Service Advisory

Product Line: Snowmobile

Advisory No: SAS310

Subject: Programming Remote Start System

Fig. 1

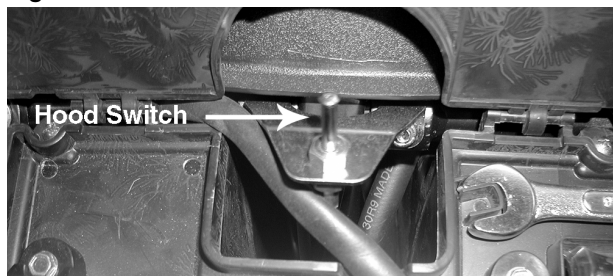
Complete step 1; then before proceeding to step 2, disconnect the hood switch connector (white/red wire). See Fig. 1 for location of hood switch.

■ **NOTE:** This step (disconnecting the hood switch) was inadvertently left out of the original instructions and must be added in order to successfully program the remote start system.

Connect the hood switch connector; then complete step 7.
